Accessibility Survey

City of Downey Horton Avenue - Pivot Street To Adwen Street

Date of Inspection
4/26/2017

Prepared By
Disability Access Consultants
(800) 743-7067

Change In Level North Of Adwen Street @ 33.944700579059, -118.145878314972

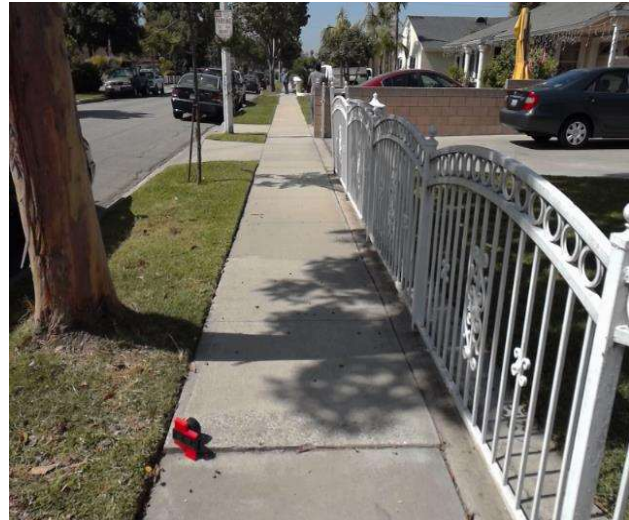
There is a change in elevation greater than recommended value.

On-Site Finding 1.25 inches

Ensure that the change in elevation is within the recommended value.

Recommendation Up to 0.25 inches

Sidewalk South Of Arnett Street @ 33.943168584868, -118.146846592426

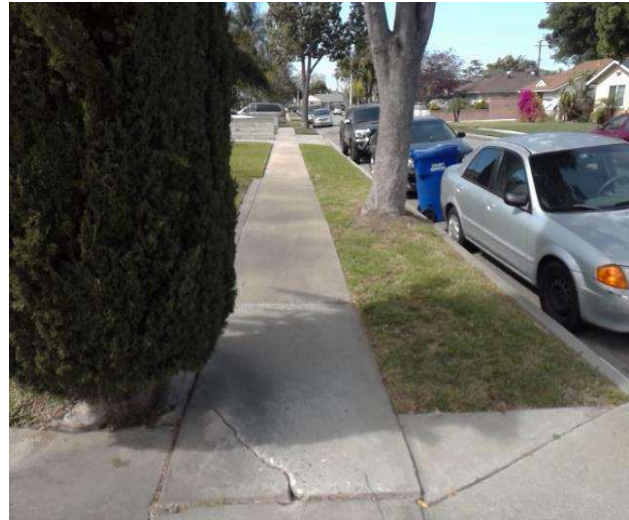
Sidewalk cross slope is not compliant.

On-Site Finding 6.00 percent for 8.00 feet

Repave the sidewalk surface with the recommended cross slope.

Recommendation Up to 2.08 percent

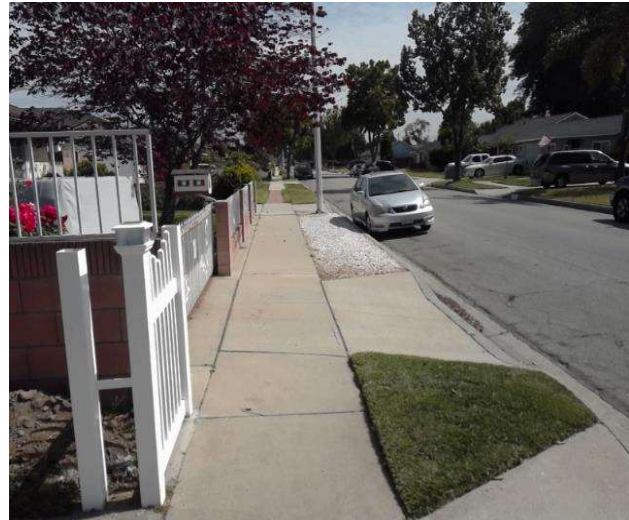
Sidewalk cross slope is not compliant.

On-Site Finding 3.60 percent for 68.00 feet

Repave the sidewalk surface with the recommended cross slope.
